CONSOLIDATING STEM AND DIAPHRAGM NUT IN 2"-3" PBT LEVER OPERATED DUMP VALVES

This product notice is to inform you that we are consolidating the stem and diaphragm nut into one stem on all 2" and 3" Piston Balanced Lever Operated Dump Valves.

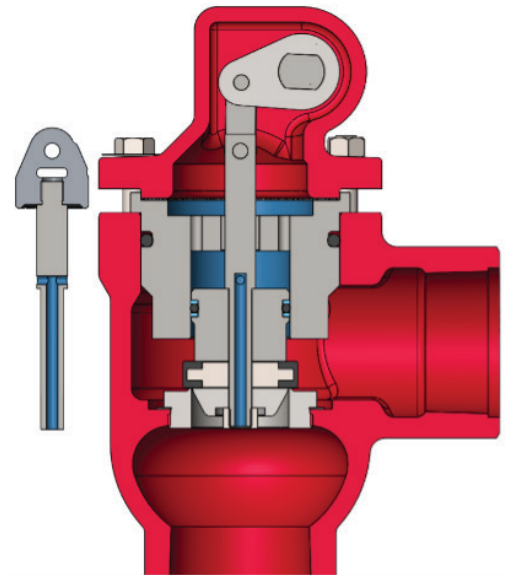
- Reduced number of components in the PBT Lever Operated Dump Valve
- Time savings on disassembly and reassembly
- Tighter tolerance in the link pin hole to help reduce rotational play in the lever arm

On the left is shown the old style stem with diaphragm nut attached. The new stem is shown installed in the valve.

The new stems will start being assembled into new products in April 2023, depending on existing stock levels.

Note that the diaphragm nuts listed above will not be discontinued since they will still be used in the Diaphragm Balanced Valves.

The current stems listed above will be discontinued.
